**SUNDRY NOTICES AND REPORTS ON WELLS**

EPCMU #32 (H-16)

BENSON-MONTIN-GREER PURPOSES TO PLUG AND ABANDON THE ABOVE WELL PER PROCEDURES ATTACHED.

**EAST PUERTO CHIQUITO MANCOS UNIT #32**  
**(H-16)**  
**PURPOSED**  
**GALLUP**  
**RIO ARRIBA, NM**

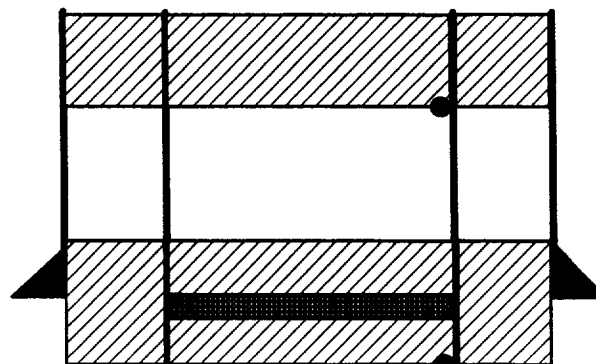
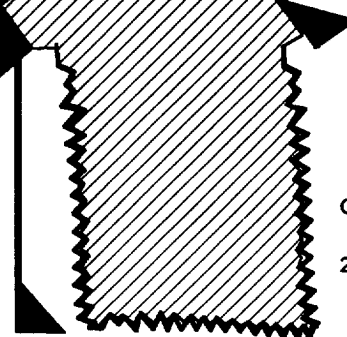
\* Changes for Shallow frac water  
- Plug 1 - chg  
- Plug 2 - displace annular cement to surface  
Plug 2 mssrs (rmbore/213 st below (room))  
- Plug 3 Change to inside plug 0-100' D st

4. **PLUG #1 (GALLUP, TOCITO, 1778' - 2186'); MIX 50 SX CEMENT PLUG AND PLACE 17 SX BELOW AND BALANCE 33 SX ON TOP OF RETAINER. POH.** ✓
5. **PLUG #2 (SURFACE SHOE, 648' - 748'); RIH WITH WIRELINE AND PERFORATE SQUEEZE HOLES AT 748'. PU AND RIH WITH RETAINER AND SET AT 698'. MIX 59 SX CEMENT PLUG AND PLACE 47 SX BELOW AND BALANCE 12 SX ON TOP OF RETAINER. POH.** 713 SXS

6. **PLUG #3 (SURFACE, 0' - 100'); RIH WITH WIRELINE AND PERFORATE SQUEEZE HOLES AT 100'. ESTABLISH CIRCULATION TO SURFACE OUT THE BRADON HEAD WITH WATER. MIX APPROXIMATELY 30 SX CEMENT TO CIRCULATE GOOD CEMENT TO SURFACE.** 59 SXS 0-100'
